254/154CLUTCH

We have introduced a new clutch in our production. Reference number 501 45 54-03.

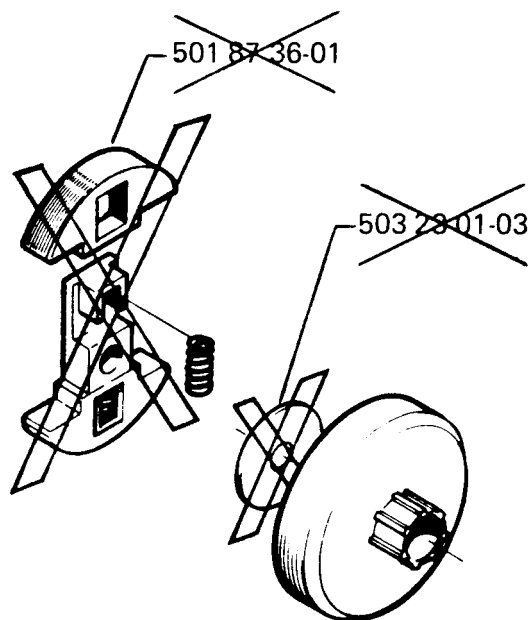
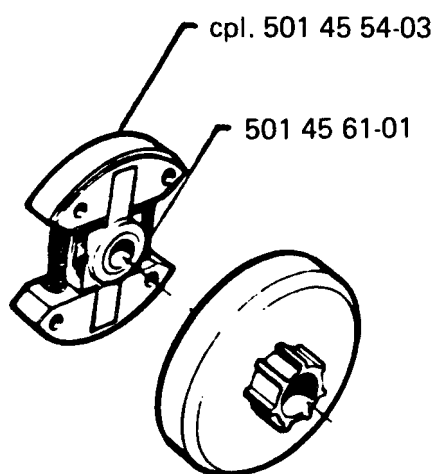
The clutch has a nut integrated with the spider (wrench size 15 mm).

NOTE! When mounting the clutch 501 45 54-03, the washer 503 23 01-03 should not be used.
